**GENWAL RESOURCES, INC  
CRANDALL CANYON MINES  
C/015/032**

**CHANGE TO  
APPENDIX 7-65**

**DIVISION ORDER DO10A, PARAGRAPH IV,  
ITEM 1  
(REVISED STIPULATION NOVEMBER 4, 2010)**

Re: Crandall Canyon Mines, C/015/032  
Response to Division Order 10A  
Paragraph IV, Item 1

<b>AS-BUILT PLAN</b>			
<b>IRON TREATMENT FACILITY</b>			
<b>Crandall Canyon Mines</b>			
Crandall Canyon			
P.O. BOX 910			
EAST CARBON, UTAH 84520			
DRAWN BY	PJ	SCALE	1" = 25'
APPROVED BY	DS	DATE	29 NOV. 2010
REVISION	1	SHEET	1 of 1

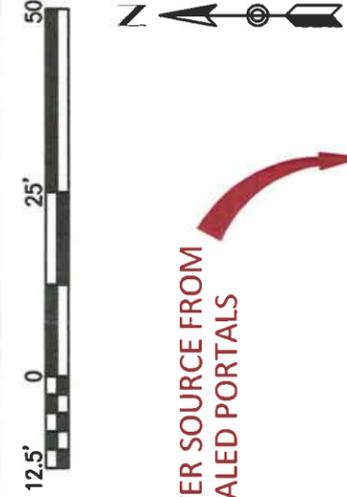
**ADD THIS “AS-BUILT” DRAWING TO THE OTHER  
DRAWINGS IN ATTACHMENT 8  
OF  
APPENDIX 7-65**
